# Access Compliance Report

## Public Rights-of-Way

### (Curb Ramps)

Intersection ID: 45302	Main Street: CINDY_CREEK_LN	Cross Street: CINDY_PARK_DR	Location: NE
ADA ID: 3A62AB45DB8A	Ramp Type: BlendTrans1	Initial Pass/Fail: Fail	Overall Compliance: No
Severity Score: 17.5			
Codes/Mitigation Info/Possible Solution		Field Measurements/Component Compliance

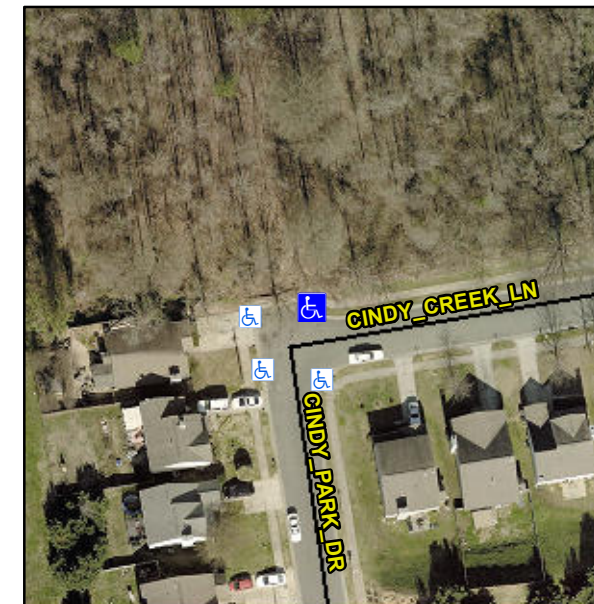
**NO LT SW**

**Not Found, R304.5.1**

**Remove & Replace Curb Ramp With Two New Directional Ramps or Equivalent.**
